Kombi Rapper RUN/COOL-DOWN Switch Failure

Models: KRI, KRII, IC1620 with Pilot Light Switch

Original Wiring of the Lighted Switch

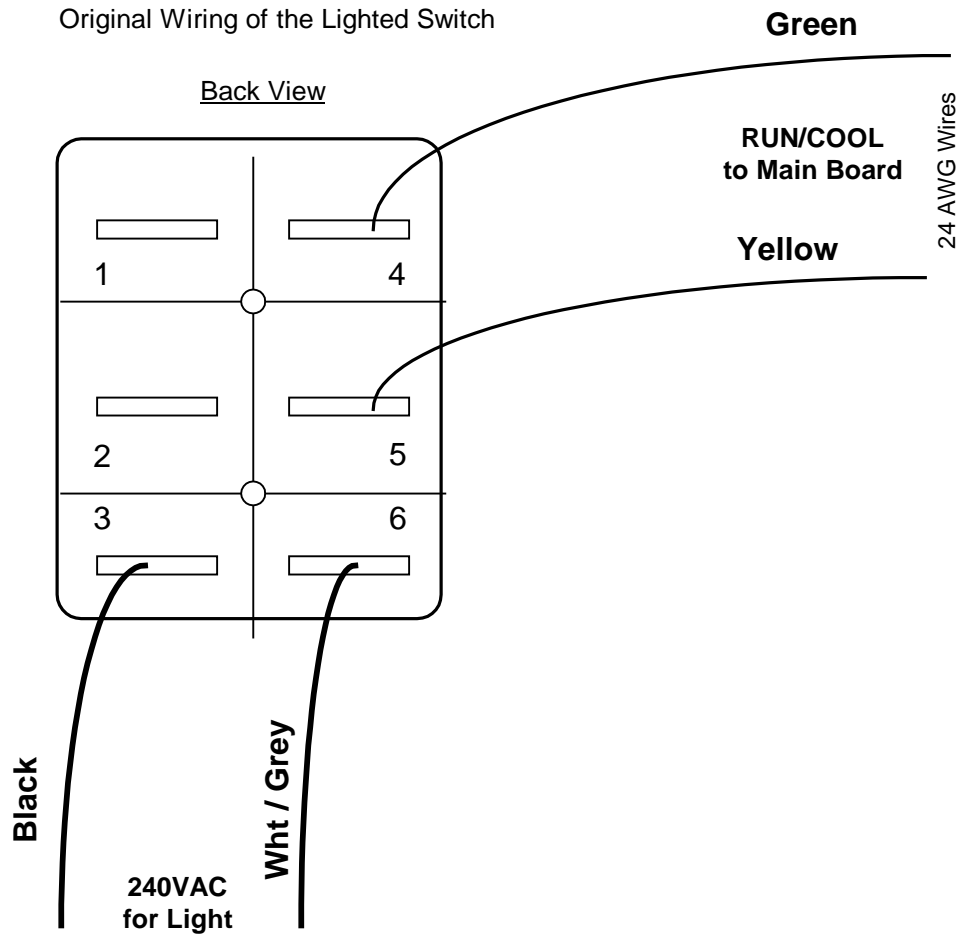
DO NOT CONNECT THESE WIRES

DUE TO REPEATED CATASTROPHIC MAIN BOARD FAILURE FROM FAILING RUN-COOL DOWN SWITCH, WE HIGHLY RECOMMEND TO IMMEDIATELY DISCONNECT THE LIGHT WIRES AND INSULATE.

AFTER YEARS OF OPERATION THE SWITCH BREAKES APART AND SHORTS OUT THE LINE VOLTAGE TO THE SENSITIVE PCB CONTROL VOLTAGE RESULTING IN A VERY COSTLY CONTROL BOARD DAMAGE. IF THE SWITCH IS BROKEN AND NEEDS TO BE REPLACED ORDER THE NON-LIGHTED VERSION PN: 5420-91

INSTALL A SEPARATE PILOT LIGHT IF DESIRED
